Work Plan
for
Non-Time-Critical Removal Action

Old Fire Fighting Training Area
NAVSTA, Newport, Rhode Island

Subject: Final Removal Action Work Plan, Soil Removal Actions,
and Response to Comments, Draft Final Removal Action
Work Plan, Old Fire Fighting Training Area, Naval
Station, Newport Rhode Island

Also enclosed, you will find responses to your comments regarding the Draft Final Work Plan dated 6/25/07 and 6/29/07, respectively.

FIGURE 1-1

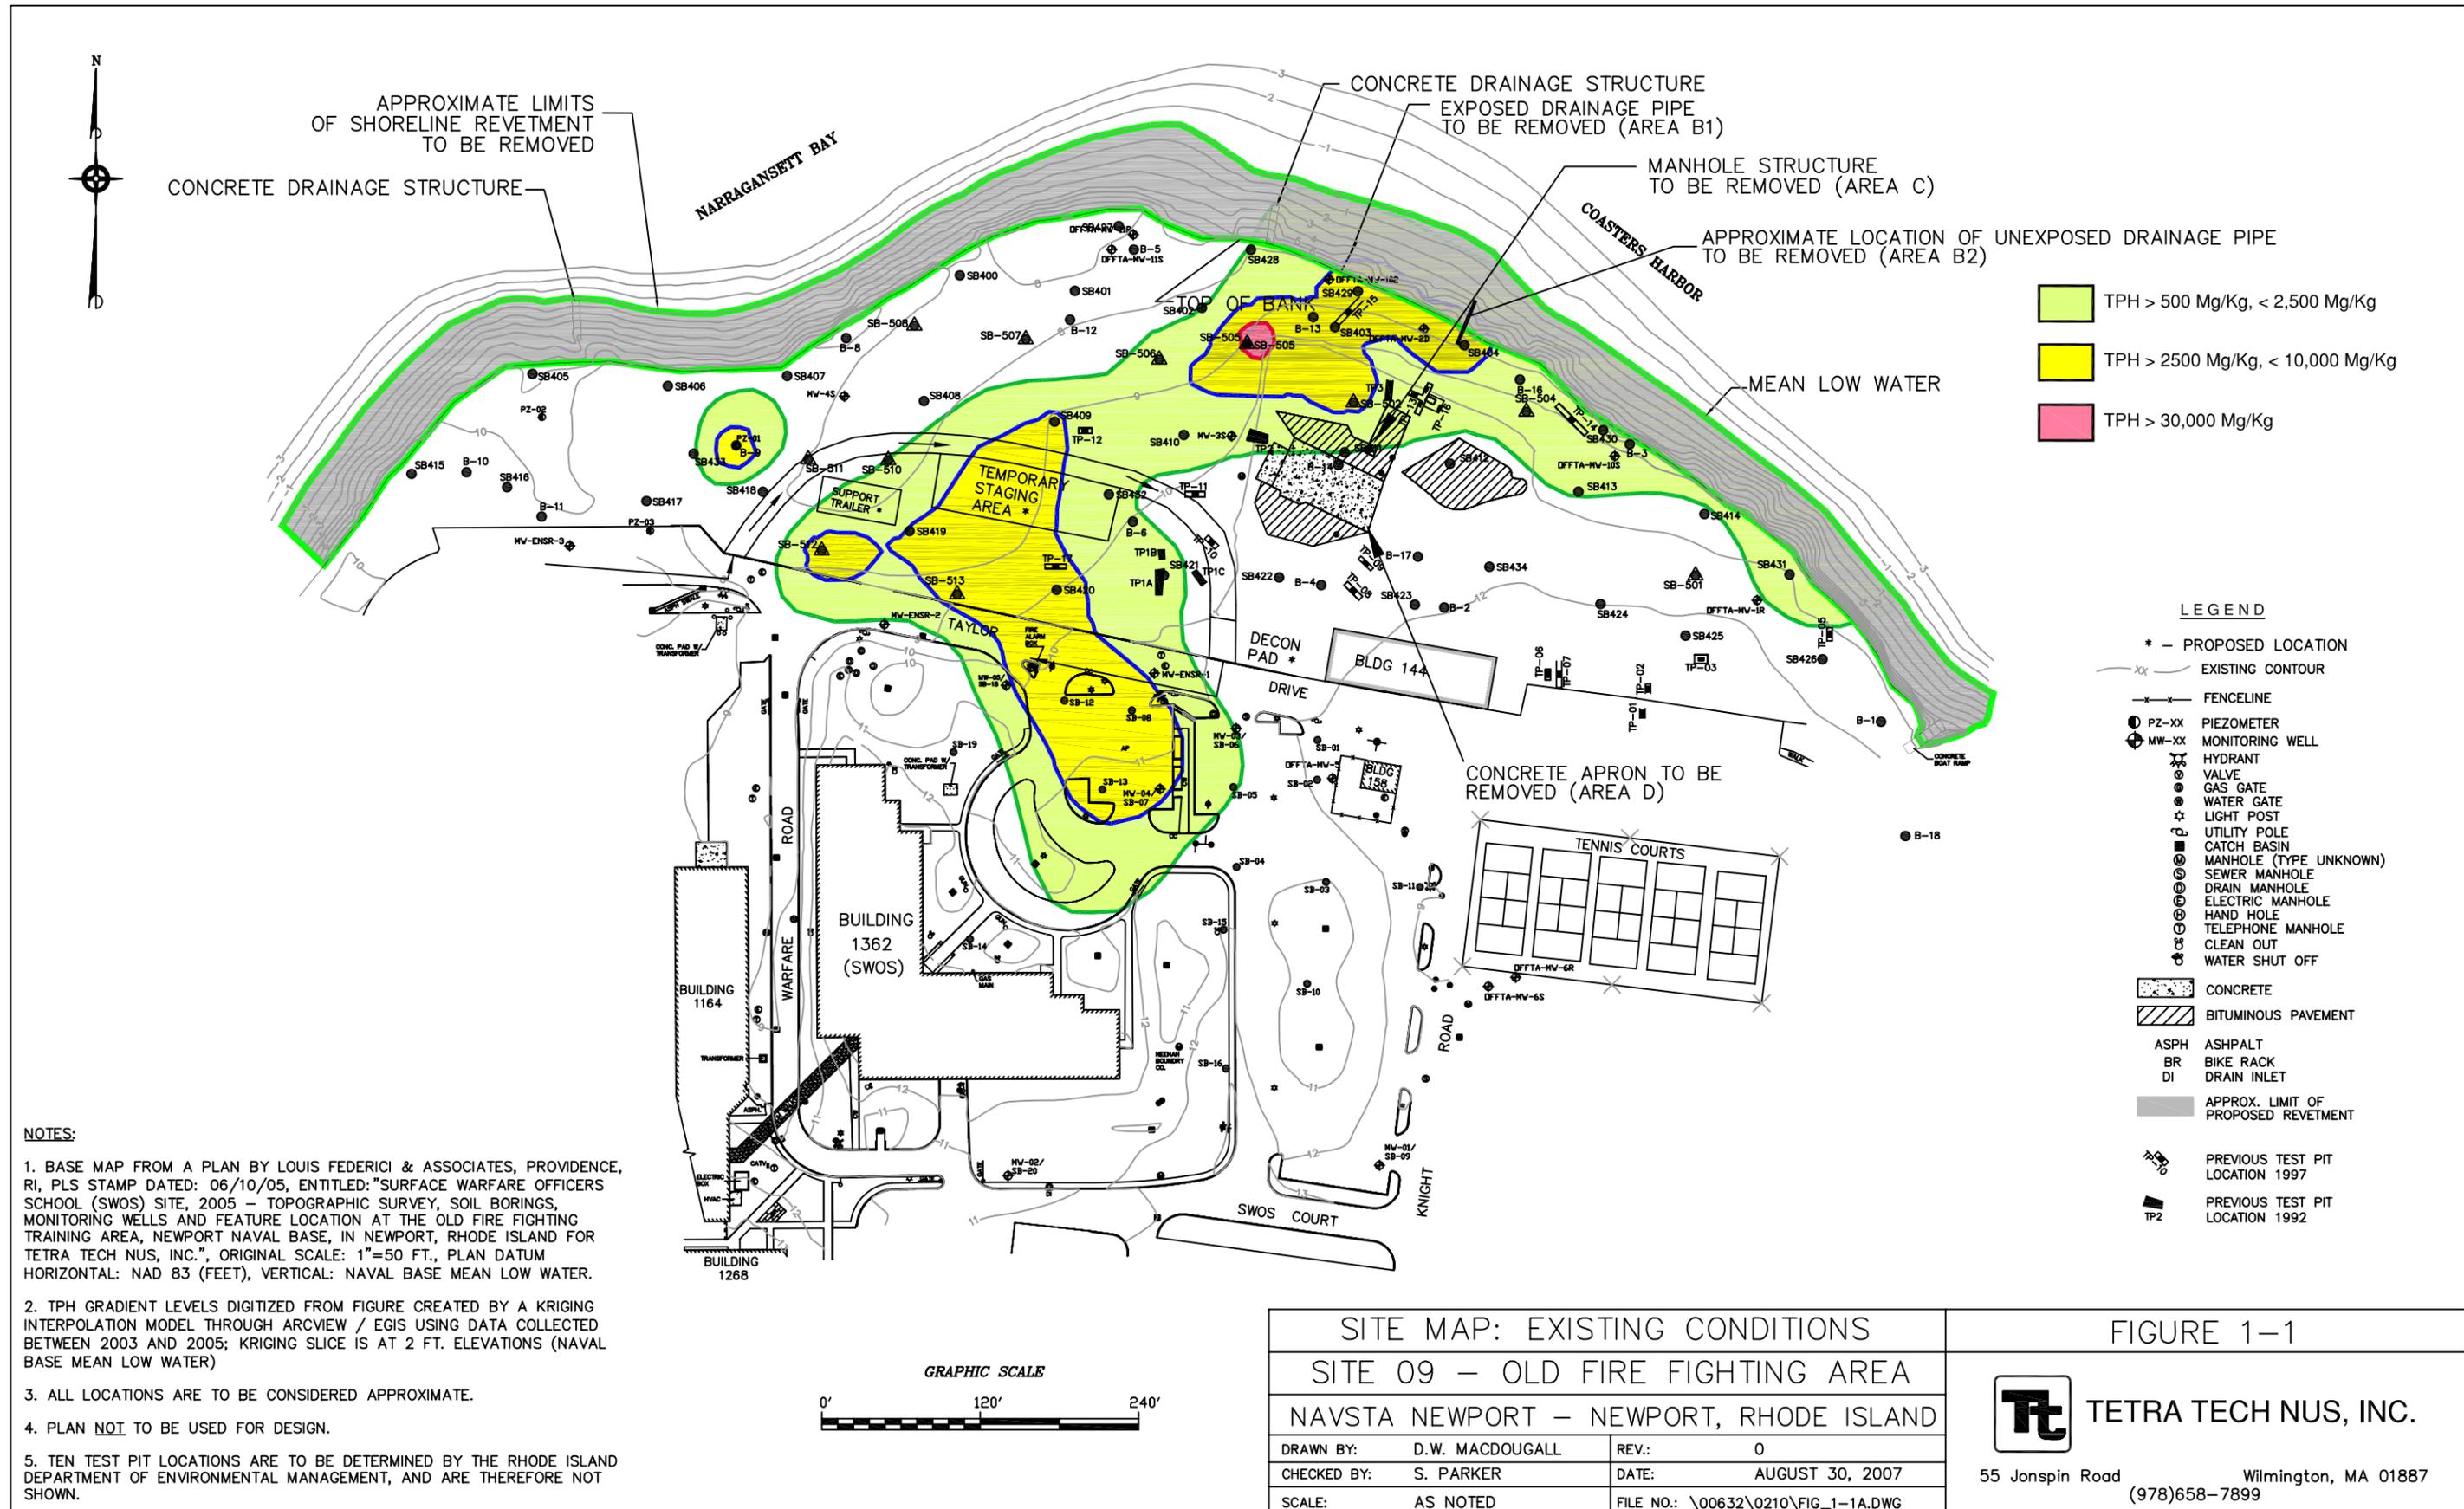
17. Figure 1-1 *This figure previously depicted the 200-foot buffer zone associated with tidal waters but did not depict the 100-foot buffer zone that the Navy said was also applicable to this site and work plan. Now however, neither buffer zone is depicted on this or any other figure in the work plan. Please explain or revise the figure to include the boundary of each applicable buffer zone.*
The extent of contamination depicted in this figure is not accurate because it does not include sampling results obtained before 2003 and the shading incorrectly identifies the contamination level of some samples at the selected kriging slice elevation, presumably owing to limitations in the kriging process. Furthermore, by only including one kriging elevation, greater contamination concentrations that exist at some locations are not identified. However, there are no locations omitted that are known to exceed the 30,000 ppm TPH threshold. This figure should more accurately depict historical results if it is included in future reports.

FIGURE 1-3

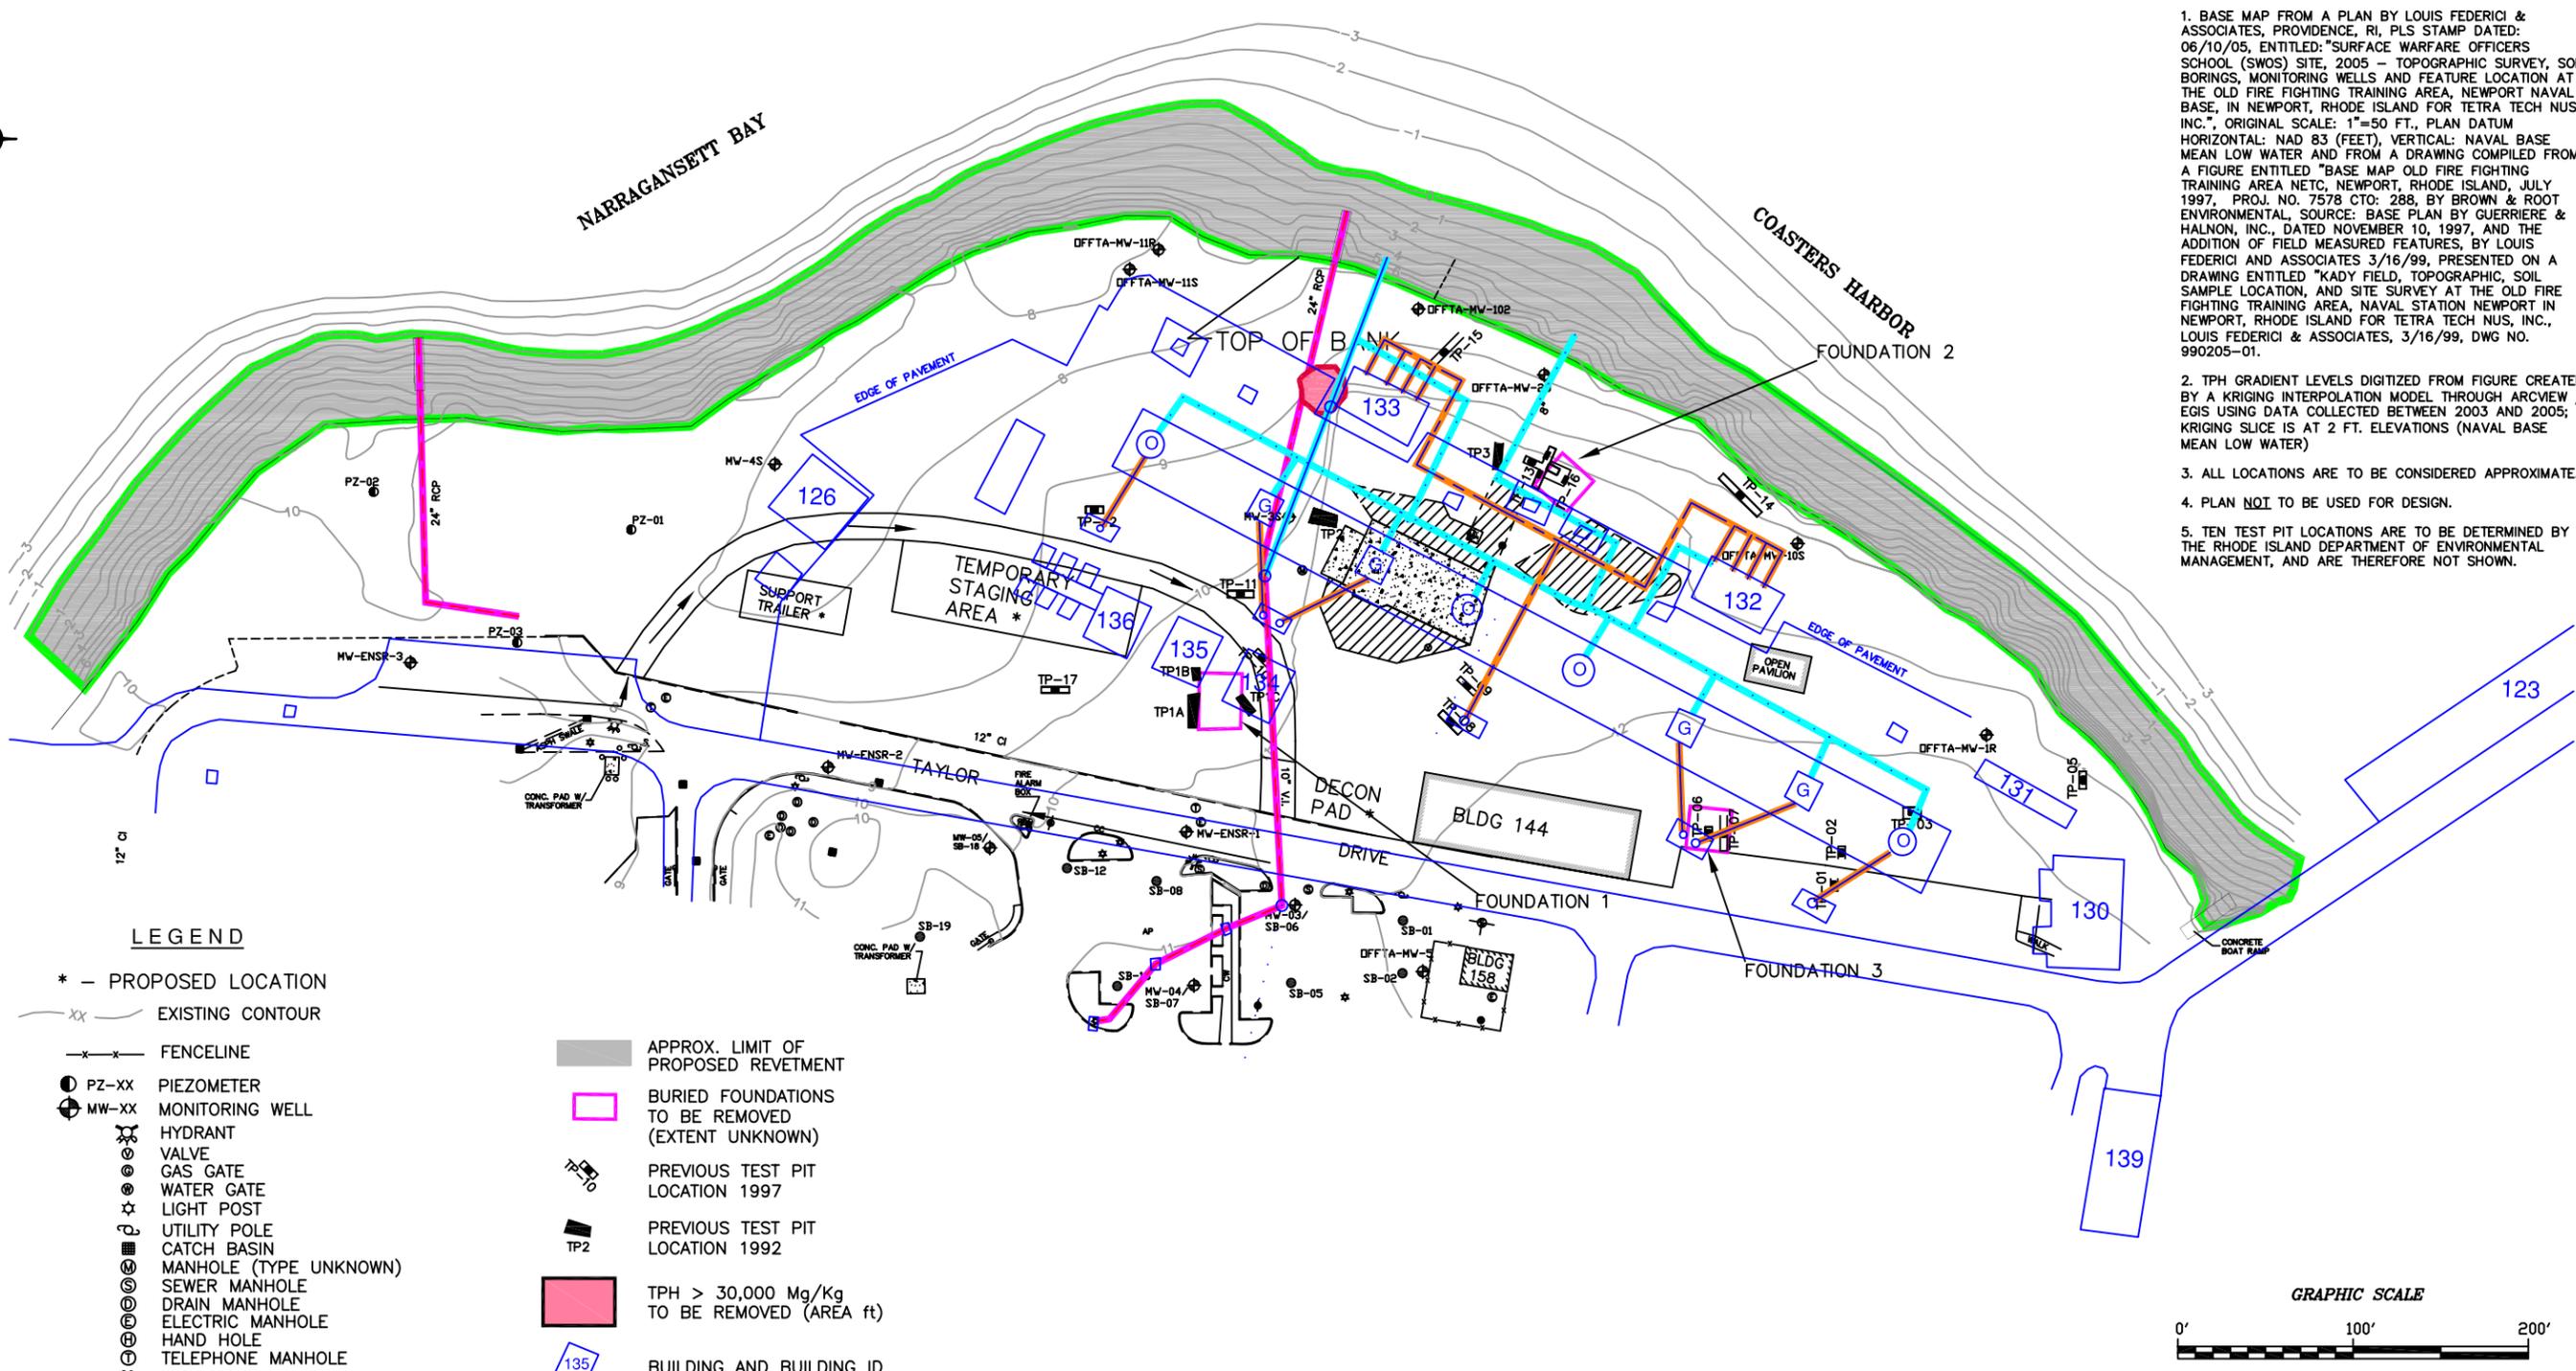
18. Figure 1-3 *Please note that Foundation 1, shown as a red box on this figure, very likely corresponds with the simulated ship structures identified as buildings 134 (based on TP1C and TP-10) and 135 (based on TP1A and TP1B) and when these structures are excavated the proposed haul road would be destroyed. The temporary storage area as well as the support trailer should be located somewhere where no historical subsurface structures were located because EPA is interested in investigating these locations during this removal action.*

21. pp. 14-16 Review of the historical drawings in conjunction with the previously conducted subsurface exploration locations (see Figure 1-3) indicates that: 1) Foundation #1 is apparently the remnants of both building 134 and 135; 2) Foundation #2 is the remnant of one of the two oil-water separators used to treat water discharged from the training structures; and 3) Foundation #3 is one of five fuel storage tanks used to provide fuel to the various training stations. As such, the estimated size of the structures appears correct (based on historical drawings) for Foundations #2 and #3, but is too small for Foundation #1.

FIGURE 5-1
Excavation Decision Tree
Removal Action Work Plan for Old Fire Fighting Training Area
NAVSTA Newport, Newport, Rhode Island

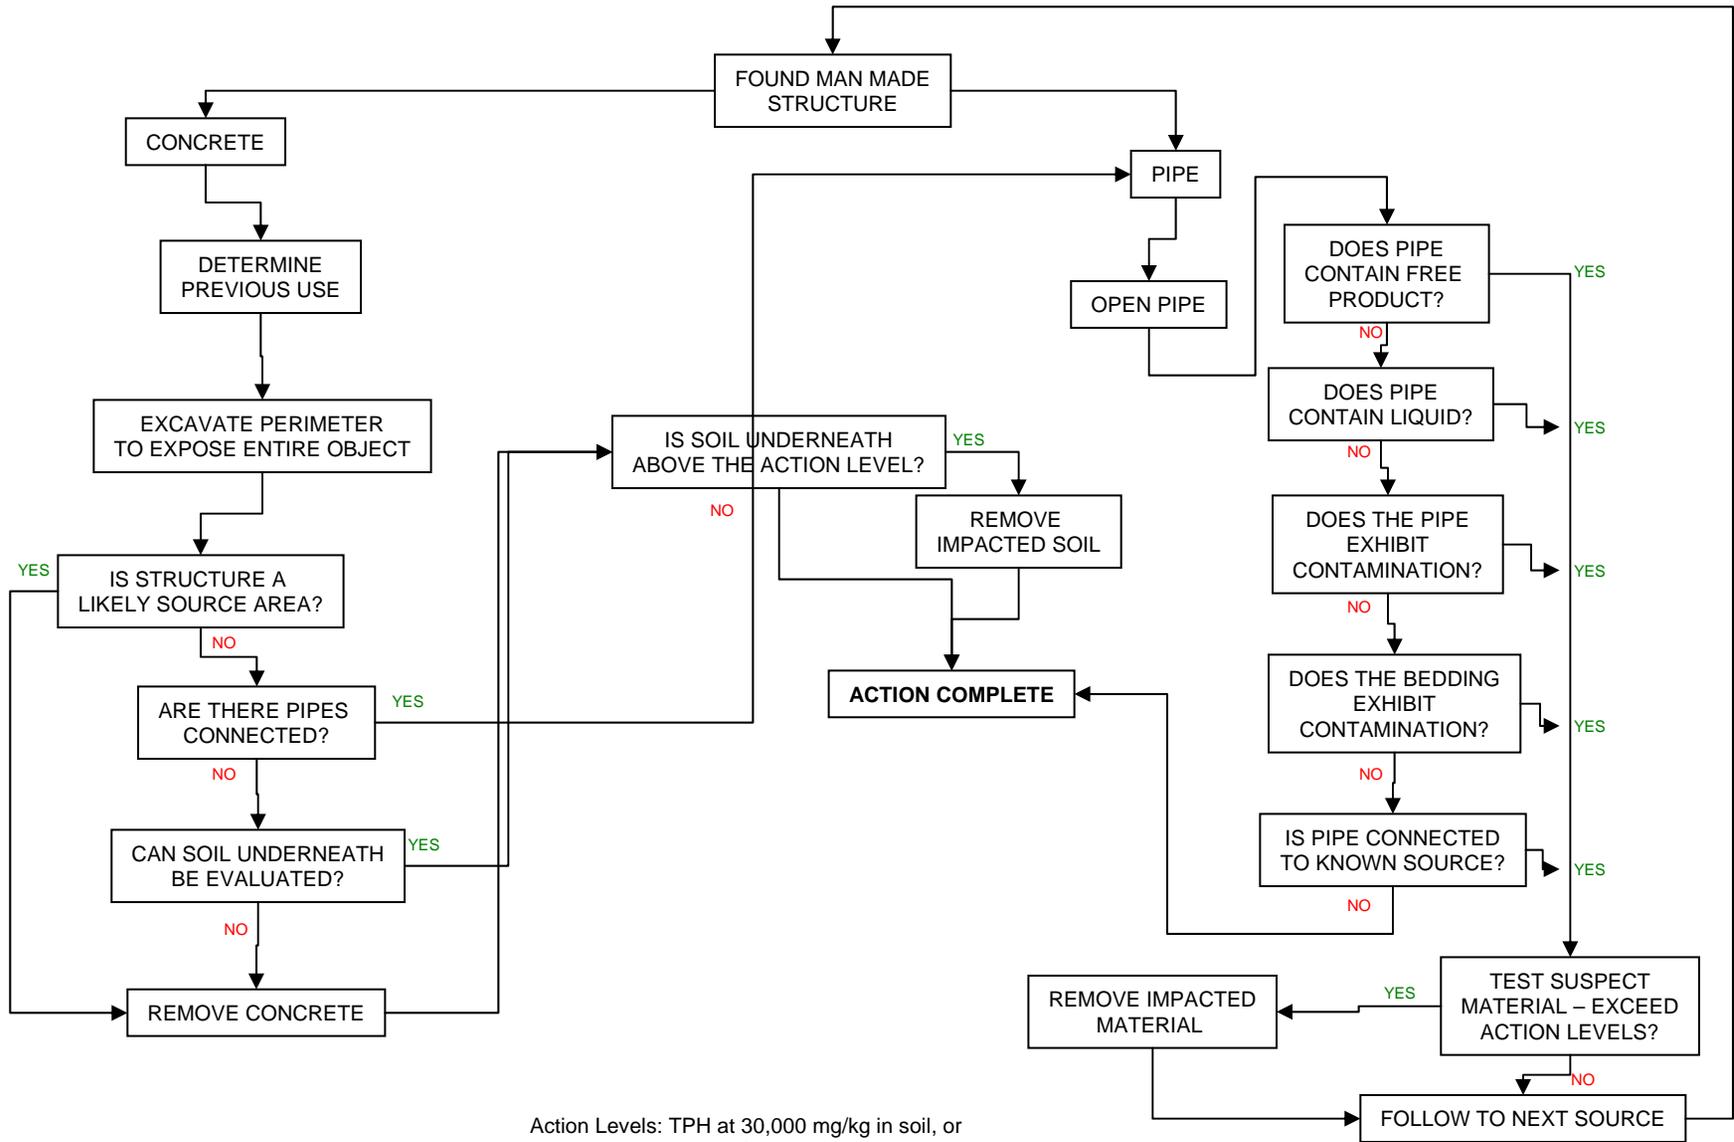
It is agreed that concrete or pipes, which is not contaminated or does not have contaminated soil adjacent to it can remain in place. To this end please modify Figure 5-1 to state that all pipes will be tracked and sampled to determine if contamination is present. Further, the report states that continuing sources of contamination will be removed. This may cause confusion in the field. As an illustration an intact tank or vault full of oil, which has not leaked, is not a continuing source of contamination. To avoid this problem in the field simply state that all structures, pipes, soil, etc which exceed criteria will be removed.

Response: The comment is noted. Use of the decision tree provided as Figure 5-1 will address findings that are unpredictable at this time.
